30 September 2019

60 Binalong Avenue, Allambie Heights
Request for modification under Section 4.56 to Development Consent
DA2018/0149 for addition of a water storage tank for fire safety purposes

Figure 1 – excerpt of the site plan indicating the location and extent of the proposed modifications

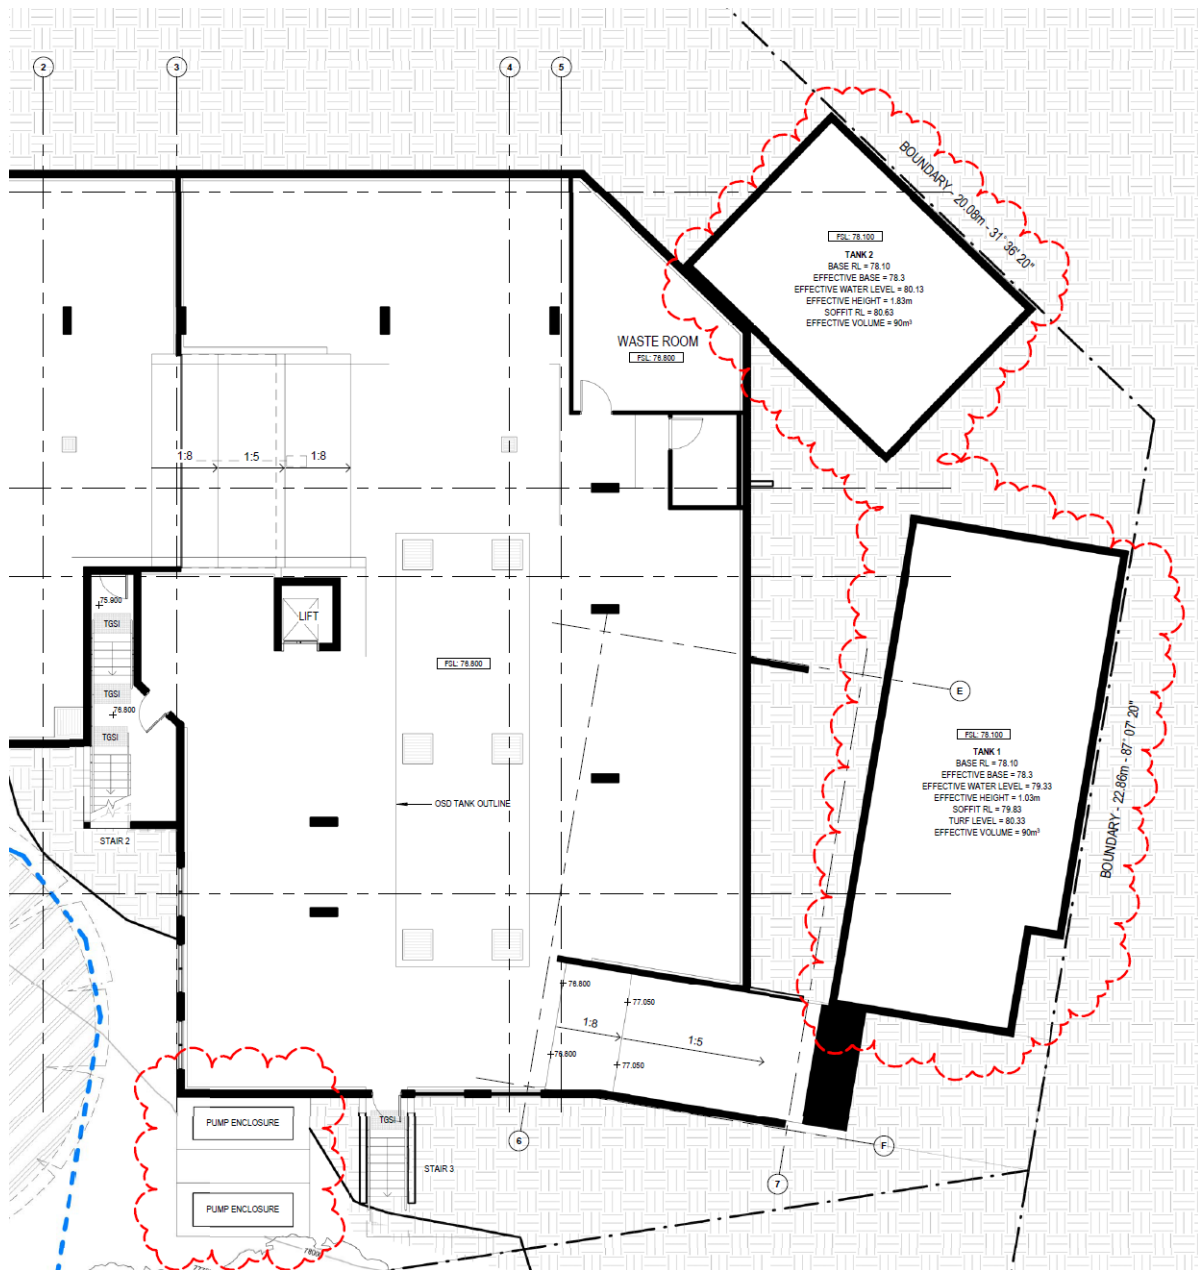
Modification to the Development Consent is sought to add a water storage tank, below ground level at the northern frontage of the property between the approved building and the front boundary at the north eastern section of the site.

- Construction / installation of 2, 90 cubic metre water storage tanks.
- Excavation within the area marked on the accompanying architectural plans to accommodate the water storage tanks.
- Landscaping modifications to accommodate the water storage tanks marked on the accompanying architectural plans.
- Installation of pumping mechanics associated with the water tanks on the eastern side of the approved development as marked on the accompanying architectural plans.

Figure 4 – excerpt of the approved landscape plan indicating the location of the proposed modifications

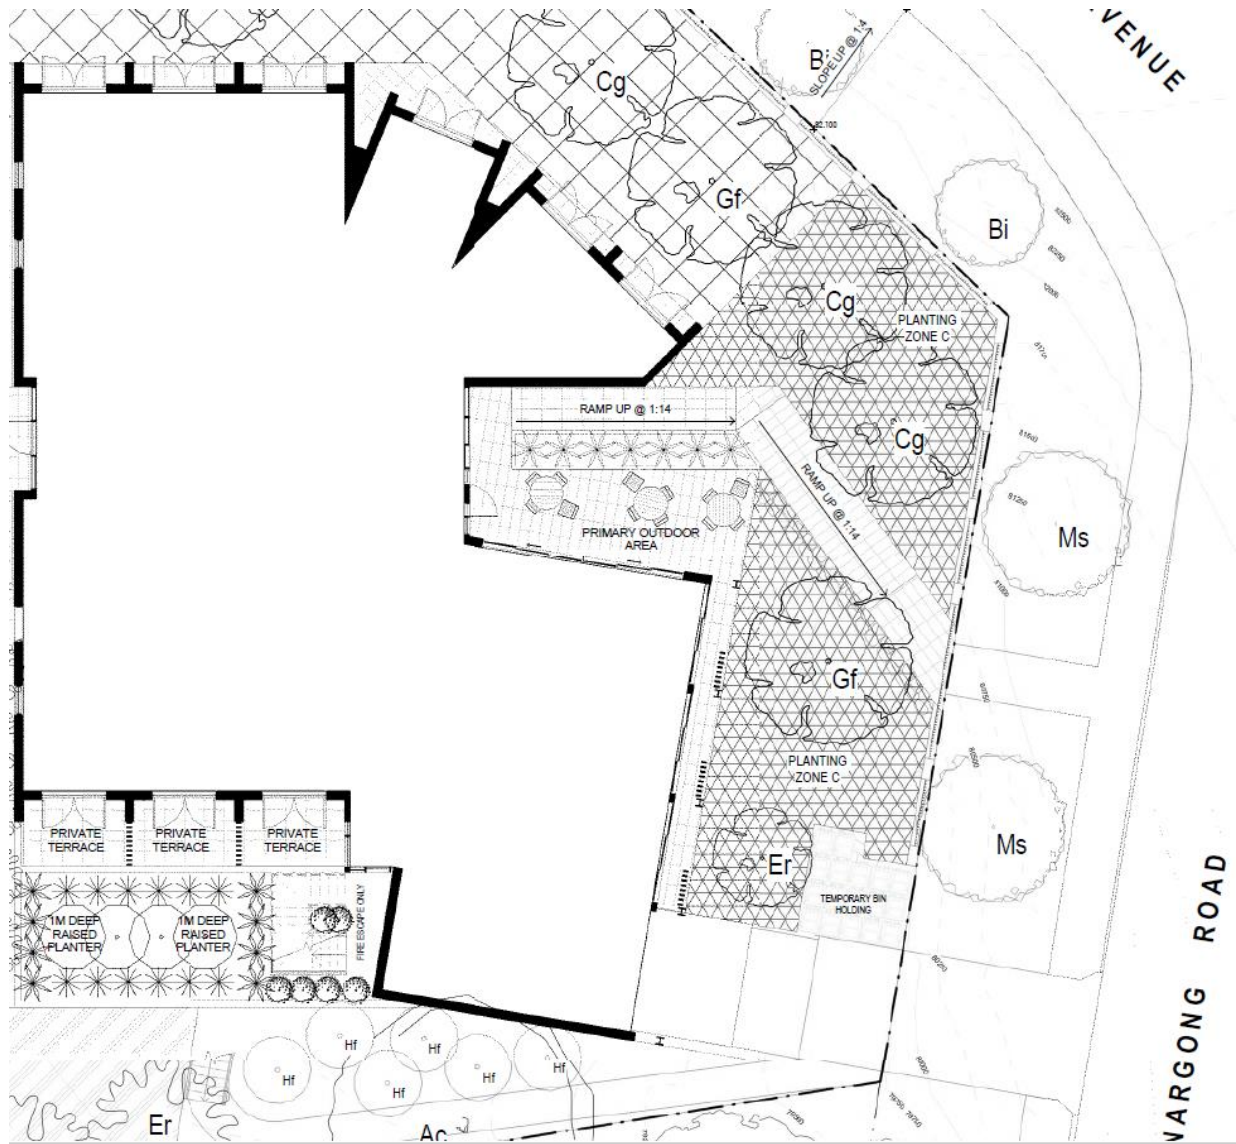
The proposed modification is supported by a revised landscape plan which indicates that the space above the tanks will be landscaped, as per planting 'Zone C' on the landscape plan (figure 6). The proposed modification is accompanied and supported by a statement from a Fire Engineering expert. The modification maintains a compliant landscaped provision for the development at 41.4% of the site area.

Landscaping will be provided over the tanks but to a depth less than 1m and therefore the area of the tanks has been excluded from the calculation of the proposed modification's landscaped area. The approved and proposed landscaped areas are compliant as stated below:
